VIRGINIA ELECTRIC AND POWER COMPANY
RICHMOND, VIRGINIA 23261

Serial No. 06-849
NL&OS/ETS R0
Docket Nos. 50-338/339
License Nos. NPF-4/7

VIRGINIA ELECTRIC AND POWER COMPANY (DOMINION)
NORTH ANNA POWER STATION UNITS 1 AND 2
PROPOSED TECHNICAL SPECIFICATION CHANGE AND
SUPPORTING SAFETY ANALYSES REVISIONS TO ADDRESS
GENERIC SAFETY ISSUE 191

Figure 2.1-1: North Anna RWST Level Low ESFAS Initiation

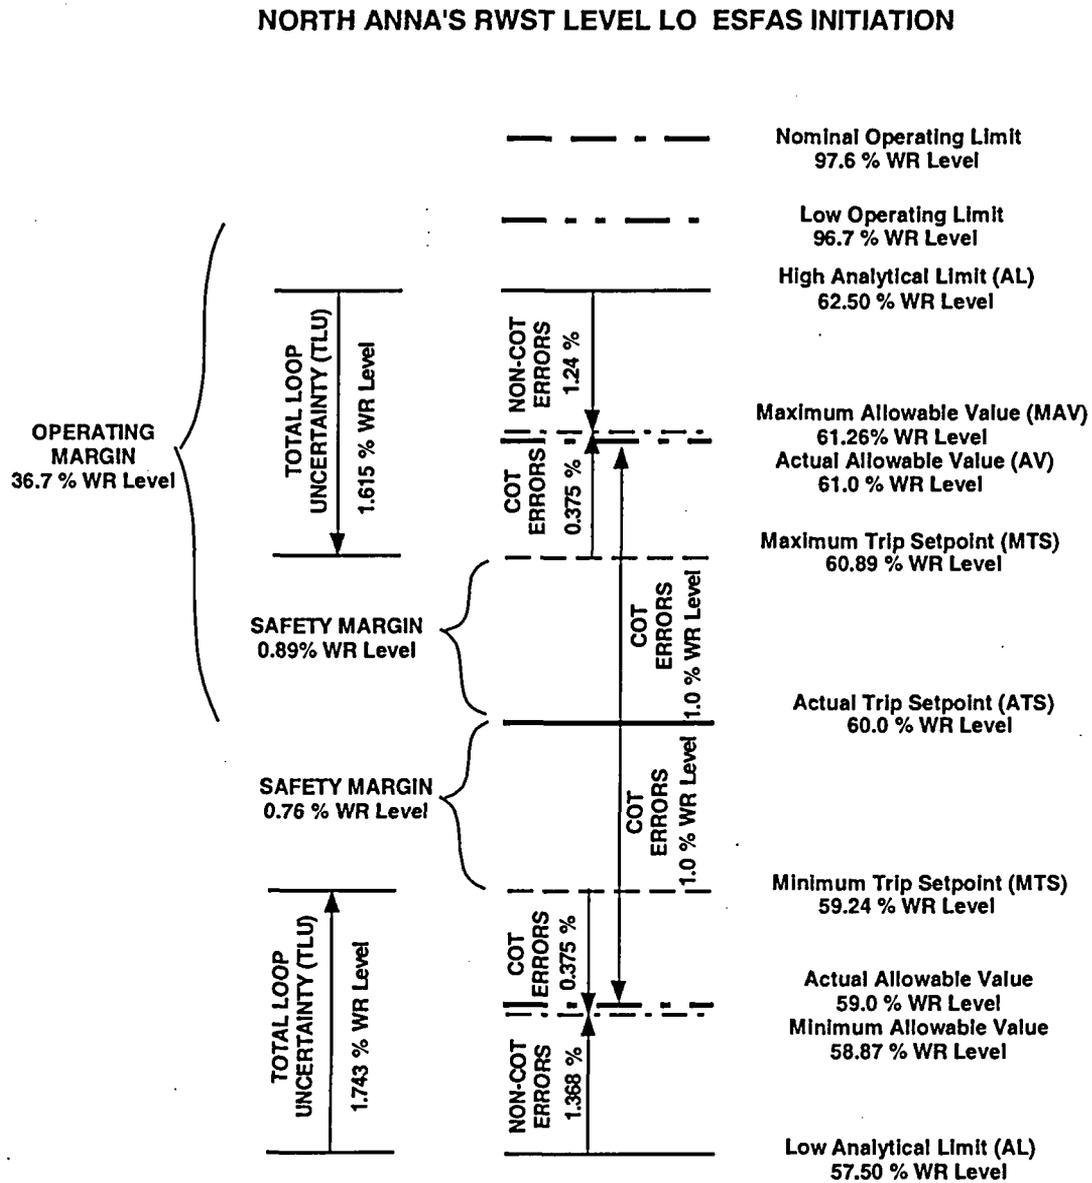
The statistical combination of the COT and Non-COT error components is provided below and used in Figure 2.1-1 to determine the Minimum/Maximum Trip Setpoints and the Minimum/Maximum Allowable Values.

- TS Table 3.3-2: Add the RWST Level Low Coincident with High High Containment Pressure as ESFAS Function 2.d with the requirement for 2-out-of-3 channels to trip and 1-out-of-2 ESFAS trains to trip. The ESFAS logic is required in Modes 1, 2 and 3 consistent with the requirements for Containment Pressure High-High (ESFAS Function 2.c). Condition D is selected for the RWST Level Low channels and Condition C applies to the Automatic Actuation Logic and Actuation Relays (ESFAS Function 2.b). RWST Level Low coincident with High High Containment Pressure has Allowable Values of $\geq 59\%$ and $\leq 61\%$ WR level.

Figure 2.1-2: North Anna RWST Level Low-Low ESFAS Initiation

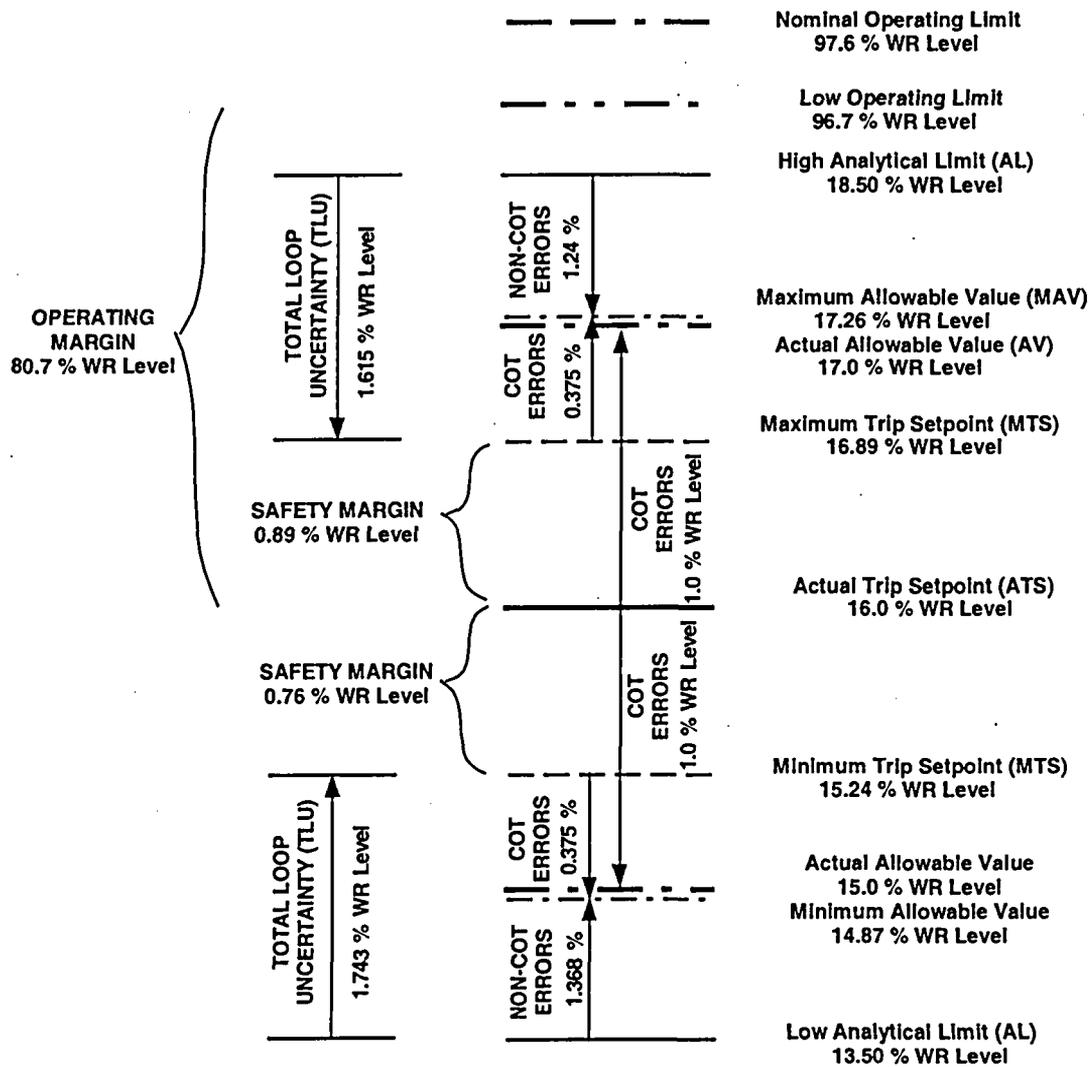
The statistical combination of the COT and Non-COT error components is provided below and used in Figure 2.1-2 to determine the Minimum/Maximum Trip Setpoints and the Minimum/Maximum Allowable Values.

Based on the above evaluations and the safety analyses in Section 3, it is proposed to change the NAPS Technical Specifications RWST Level Low-Low function Allowable Values to $\geq 15\%$ and $\leq 17\%$ RWST WR level.

**Figure 3.10-1: Containment Air Partial Pressure versus Service Water Temperature
(Proposed TS Figure 3.6.4-1)**

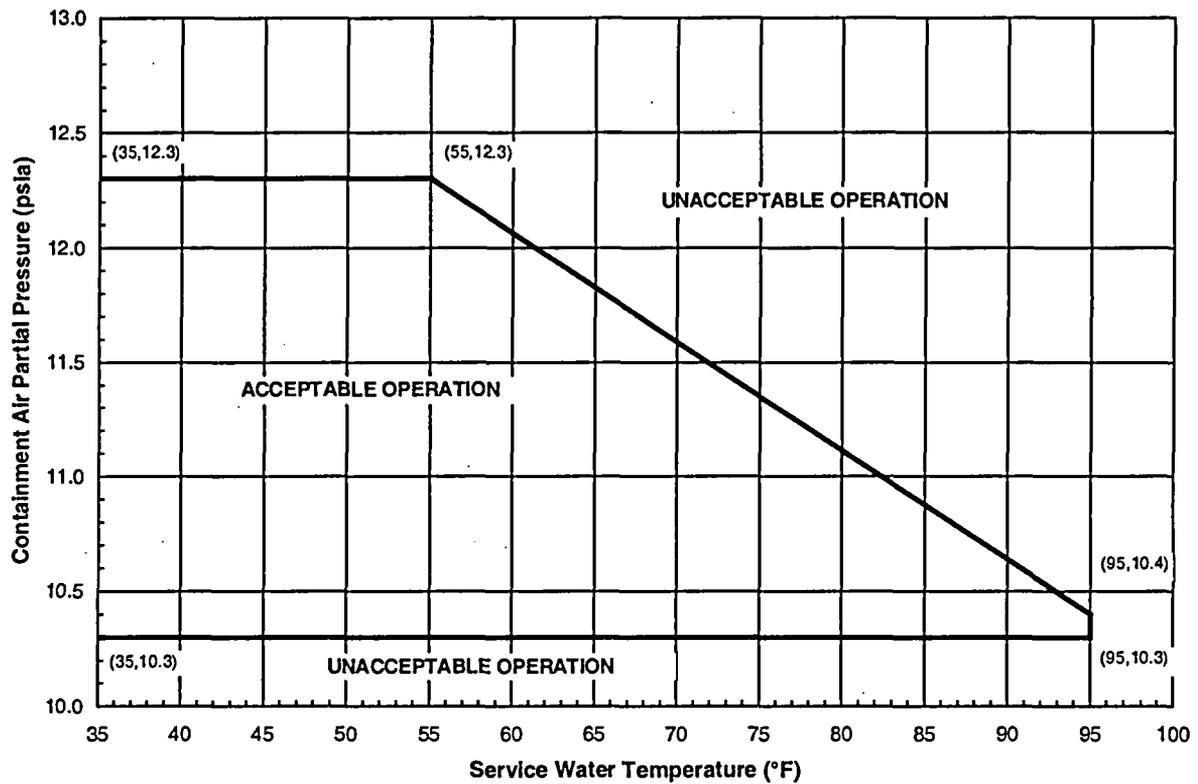
- The LHSI pump NPSH analyses set the lower limit on air partial pressure (the RS pumps use the same assumptions but have more NPSH margin). The proposed lower limit in Figure 3.10-1 ensures at least 1.5 ft of NPSH margin for the LHSI pump at recirculation mode transfer across the entire SW temperature range.

- ❑ Replace the containment air partial pressure operating limits in TS Figure 3.6.4-1 with Figure 3.10-1 in this report.
- ❑ Reduce the containment temperature operating limit in TS 3.6.4 and TS 3.6.5 from 120 F to 115 F.

Figure 3.6.4-1: Containment Air Partial Pressure Versus Service Water Temperature

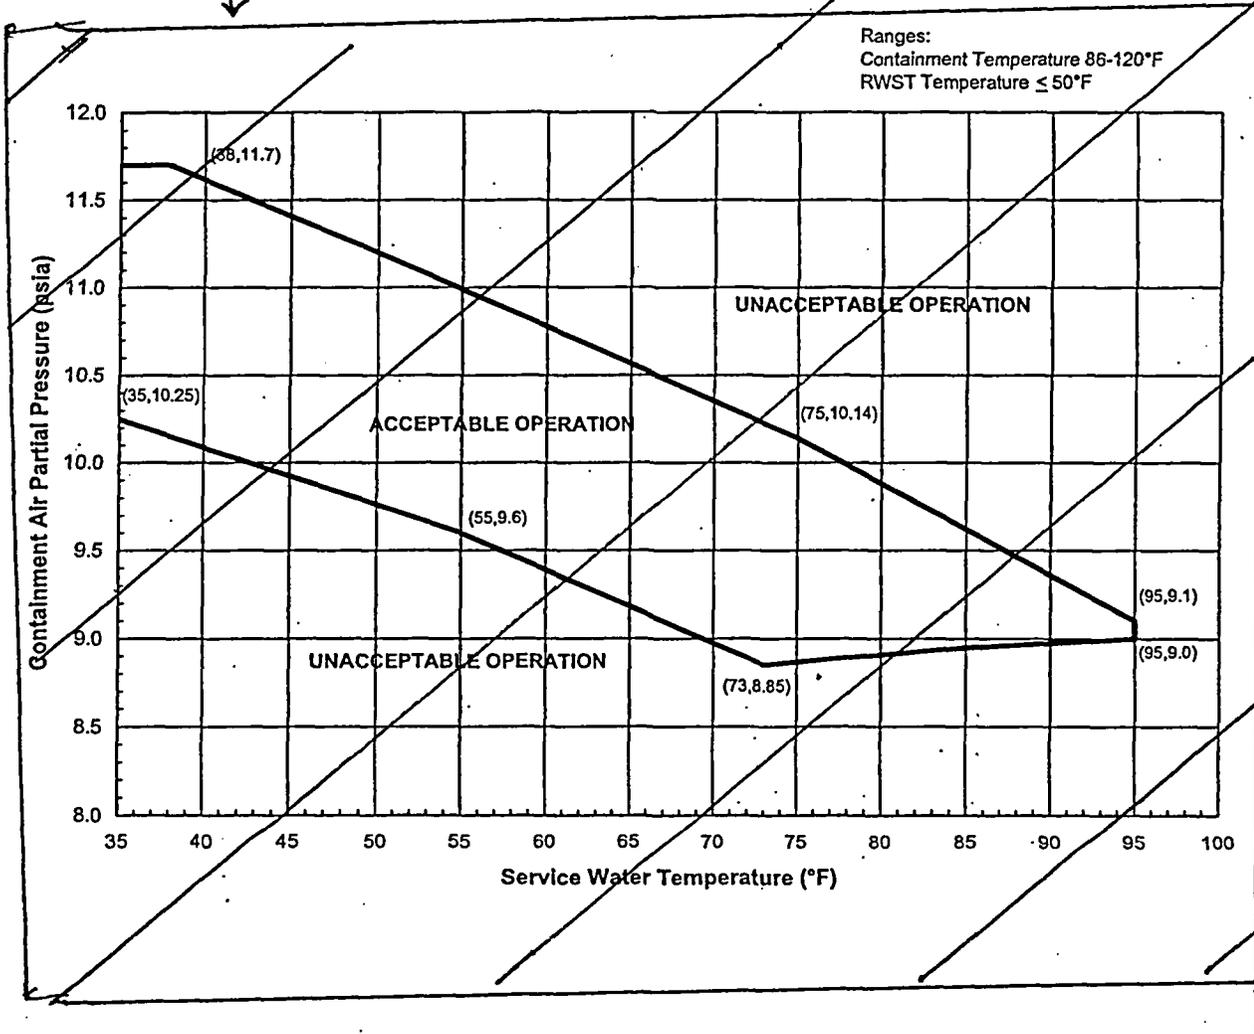
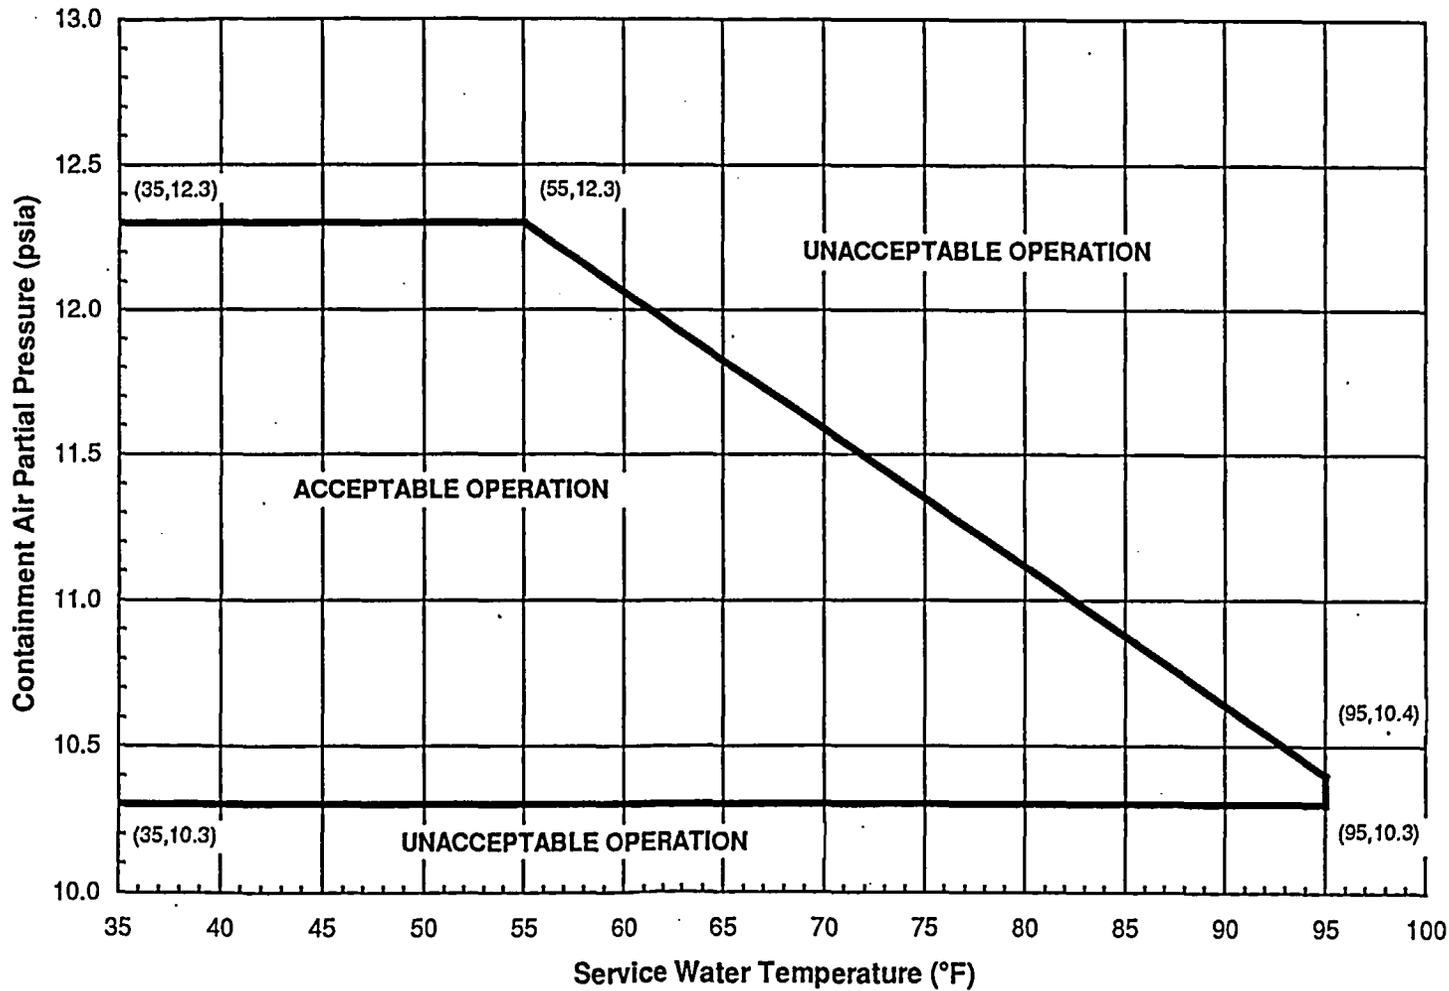
REPLACE WITH NEW Figure 3.6.4-1 INSERT A

INSERT A for TS 3.6.4: Replace Figure 3.6.4-1 with the below figure
